**DOCUMENT 00 90 00  
ADDENDUM**

**ADDENDUM NO. [2]                      Date: January 19, 2018**  
**RE:                      ABBOTSFORD SCHOOL DISTRICT**  
**ELEMENTARY & MIDDLE SCHOOL ADDITION**  
**510 HEMLOCK STREET**  
**ABBOTSFORD, WISCONSIN 54405**  
**HSR PROJECT NO. 17060**

**A002R**

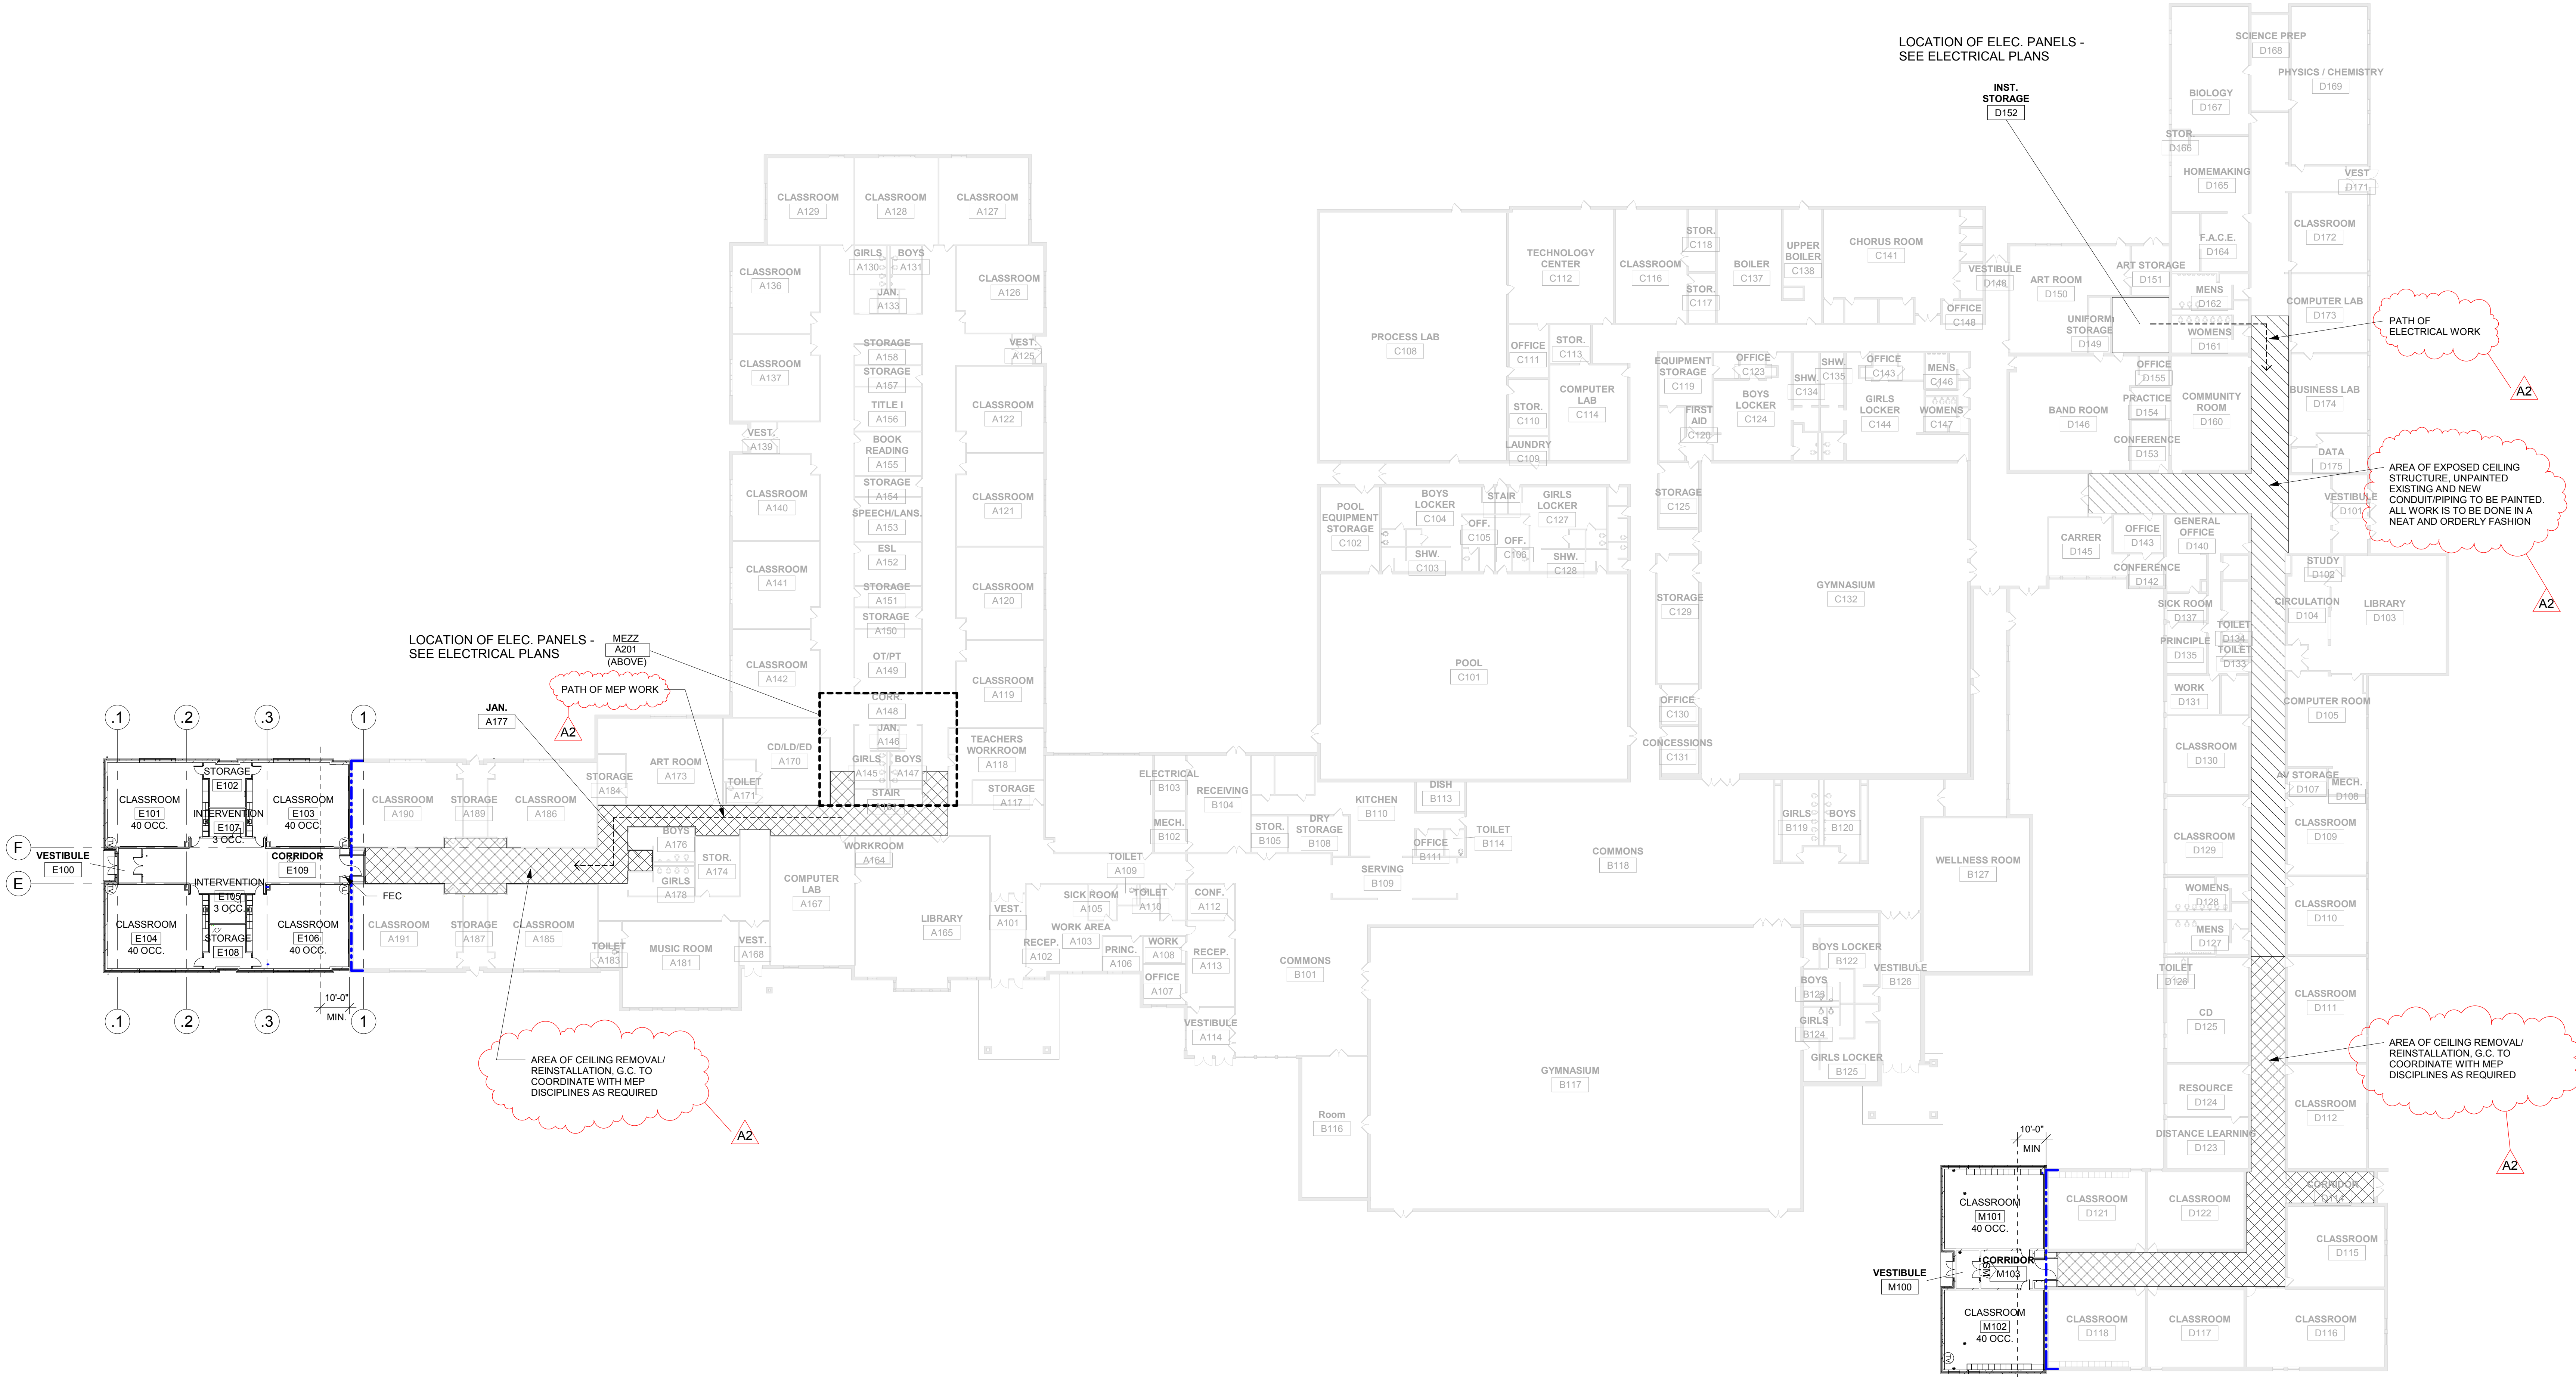
10. Sheet A002R OVERALL BUILDING PLAN 30 x 42 attached hereto
  - a. General Contractor shall be responsible for removal/reinstallation of ceiling panels for required MEP work above ceiling in existing corridors. Remove/reinstall grid only as required to accomplish work.

- b. Extents of new and existing conduit/piping locations at exposed ceiling to be painted.
11. Sheet C100R LAYOUT PLAN 30 x 42 attached hereto
  - a. Storm sewer revision at west end of addition.

**C200R**

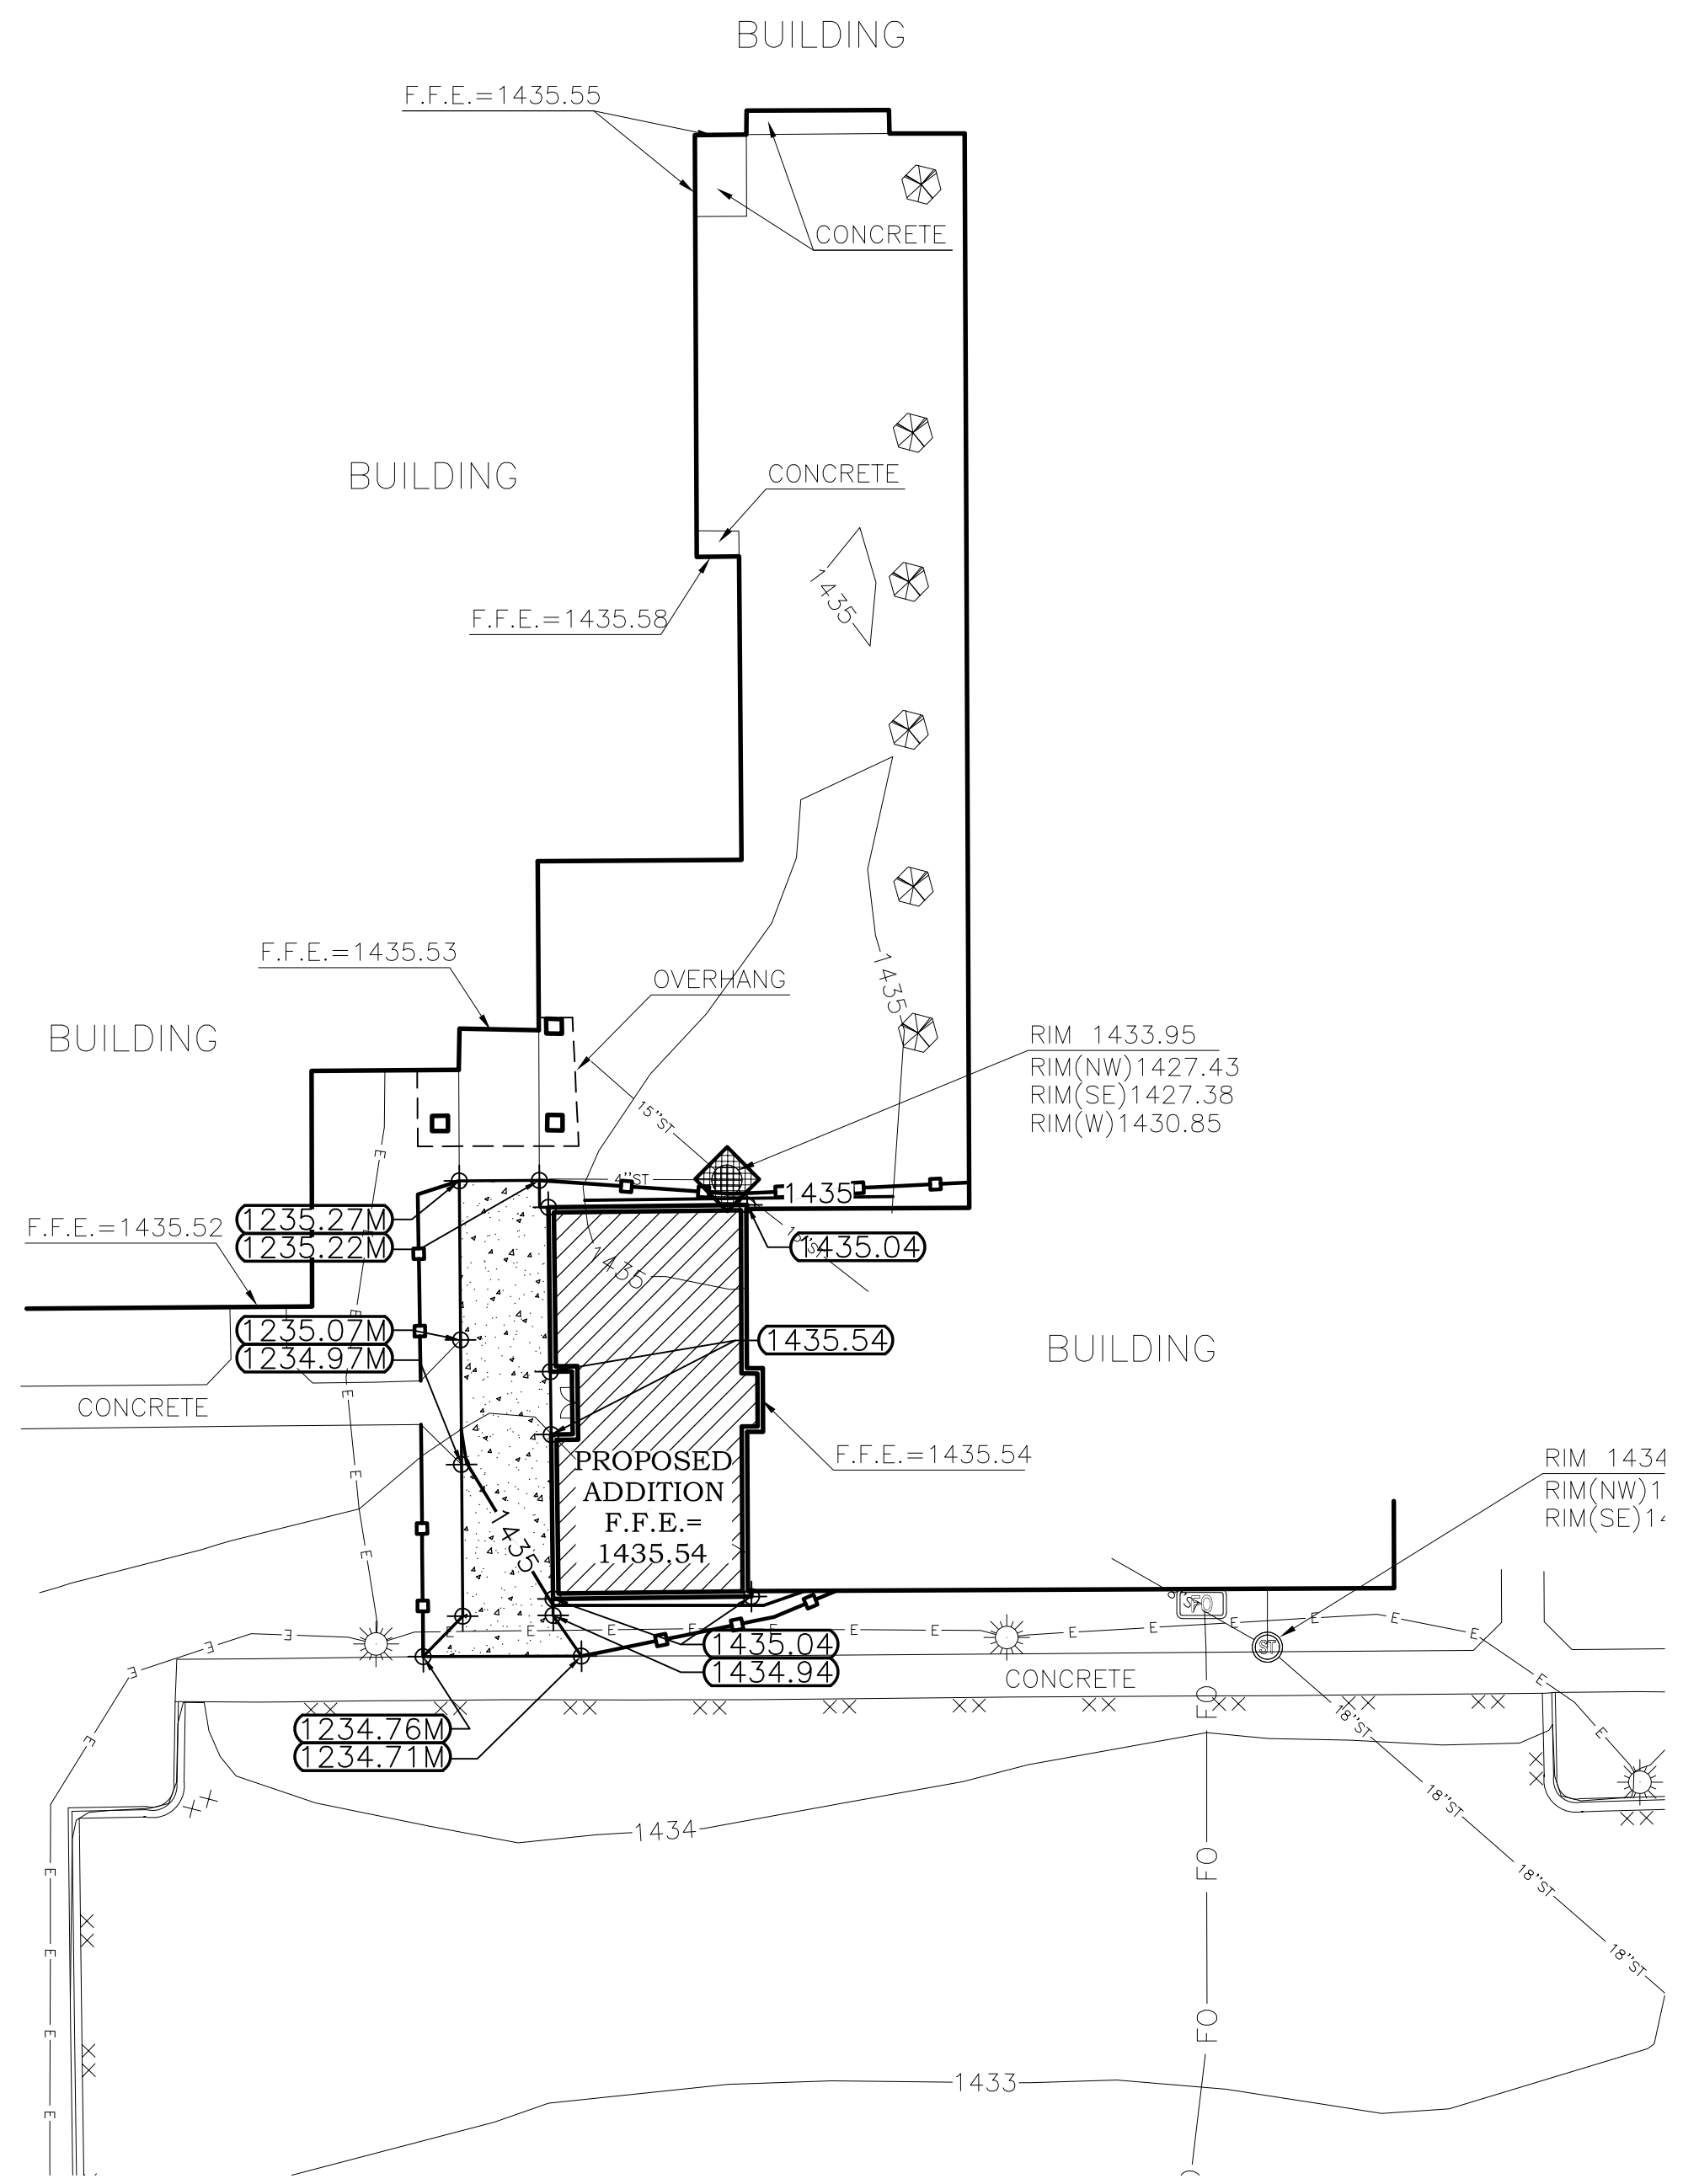
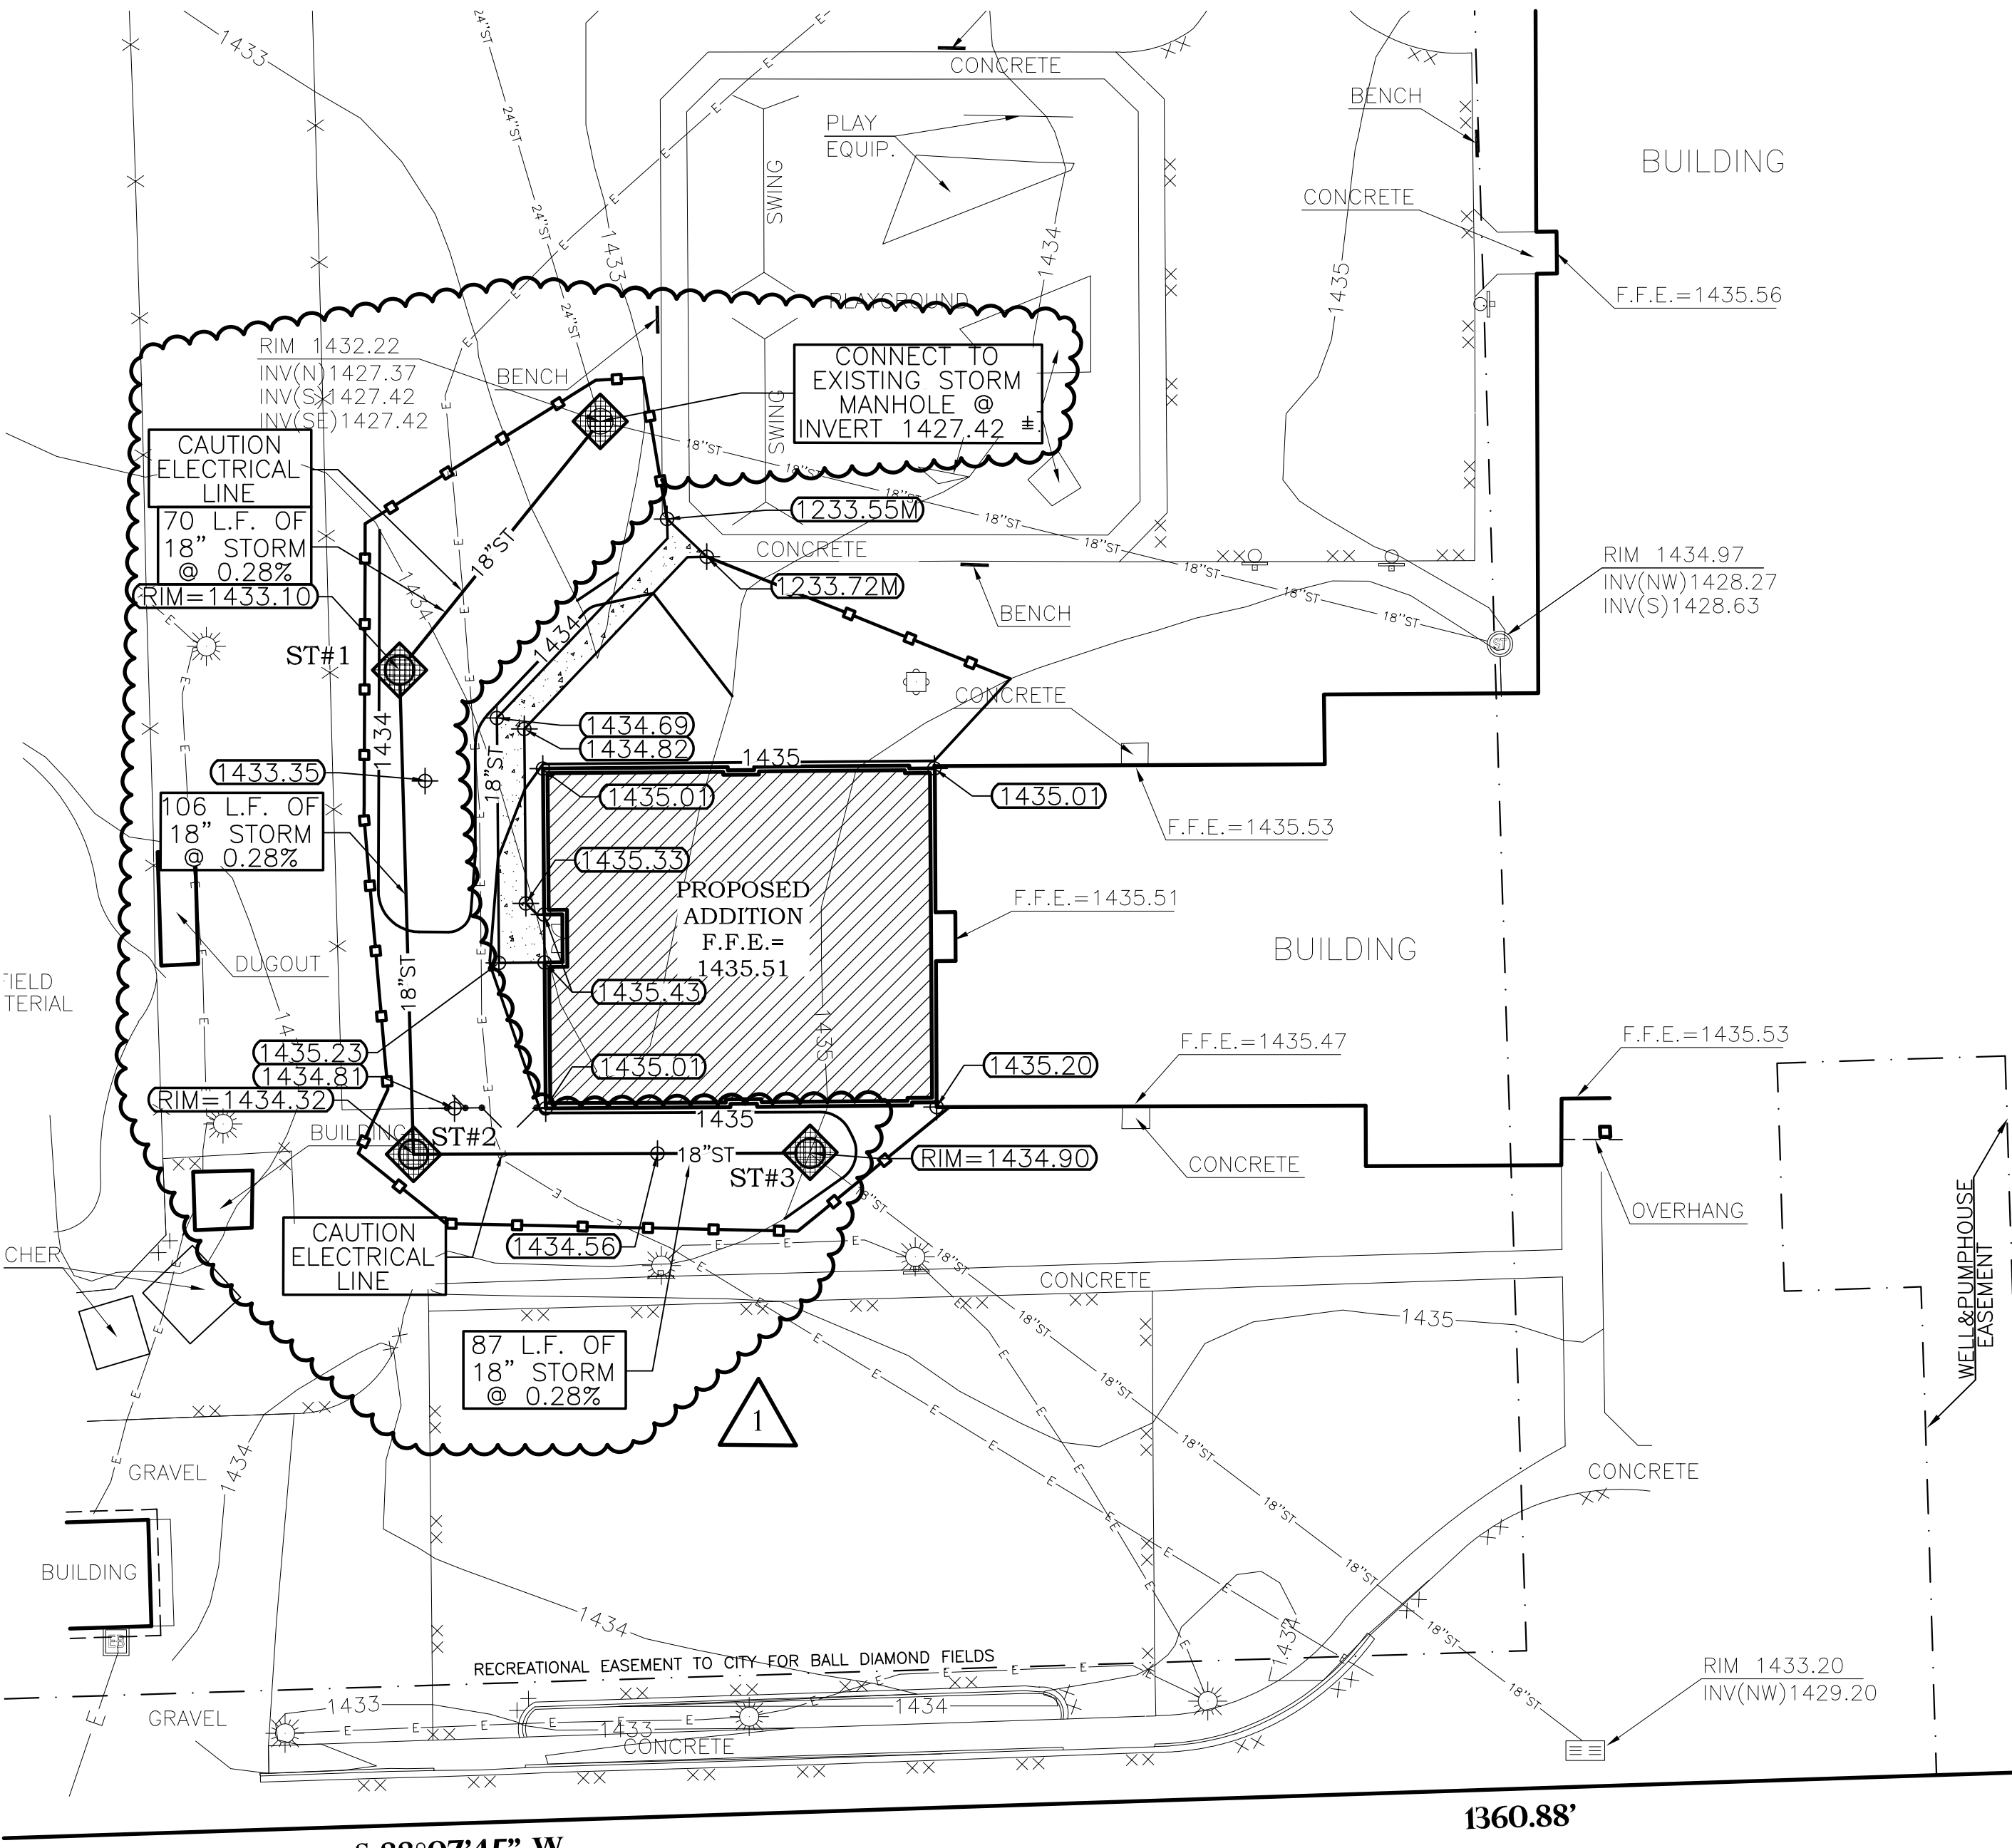
12. Sheet C200R GRADING-EROSION CONTROL-UTILITY PLAN 30 x 42 attached hereto
  - a. Storm sewer location and number of catch basins revised to minimize interference and relocation of existing electrical service line. Existing electrical line shall be stabilized/shored in place where storm line crosses.
